Dossiernummer: W.Z20.106796.02
Adres: Hollandiaweg 11 te Nijmegen
Omschrijving: slopen CG bovengronds
Aanvrager: ENGIE Energie Nederland NV

Opmerkingen bij de aangeleverde stukken

Title: Design for the Demolition of the Boiler House and Turbine Pedestal using Controlled Explosives. Date: 5th August 2022

Report Concerning the Vibration Levels Associated with the Proposed Demolition of the Event 3 Structures at Gelderland Power Station, Nijmegen, Netherlands BROWN AND MASON GROUP LIMITED

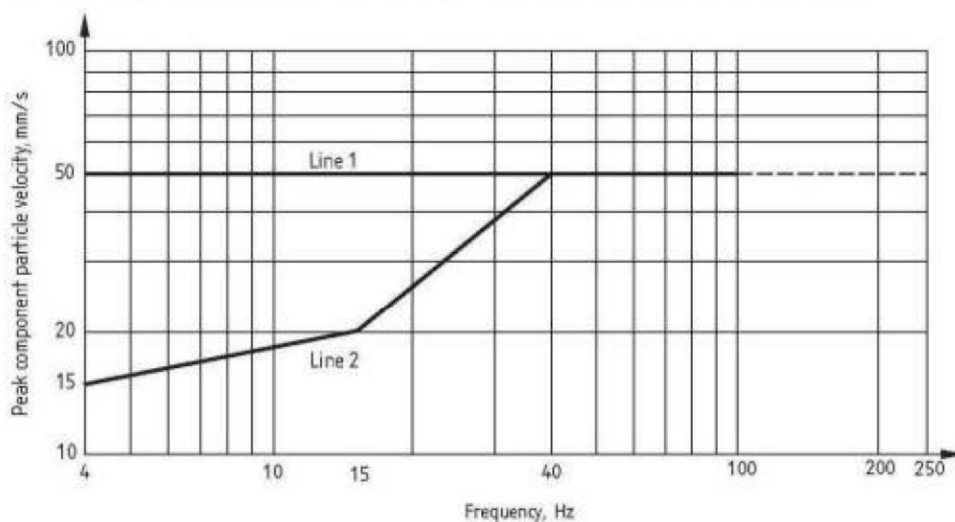
Volgens tabel boven 15 Hz. Onderstaande grafiek laat overgang zien.
